Old XPSAT substituted by new XPSATE

How to substitute old XPSAT unit
with time-delayed outputs by the
new equivalent XPSATE

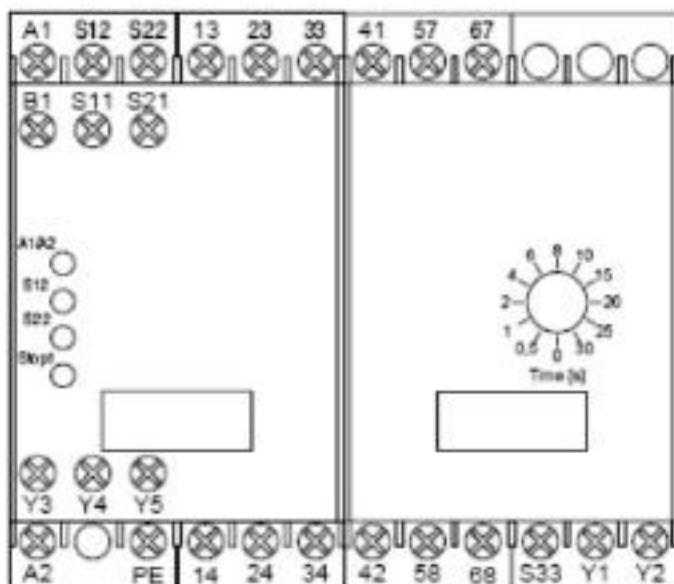
• Main differences

Unit model	Safety Function Monitoring										Output contacts nb				Enclosure width mm	Electr. Fixed	Conne ^c . Pull	Approvals			
					Category				safe		Unsafe		UL	CSA/C-UL				BG/TuV			
					2	3	4	24V DC	24V AC	120V AC	230V AC	NO							Time delay	NC	
XPSATE	●	●		●		●	●	●	●	●	2	3		4	45	●	●	●	●		
XPSAT	●	●		●		●	●	●	●	●	3	2	1		90	●		●	●

Repérage des bornes / Terminal marking

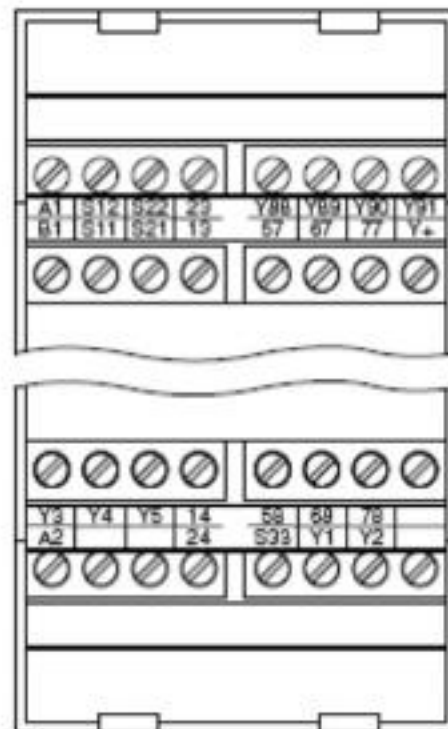
• Easy substitution

- All connection terminals are at the same side in the front face
- Terminals and wiring diagram are the same in the substitution for the inputs and the existing outputs
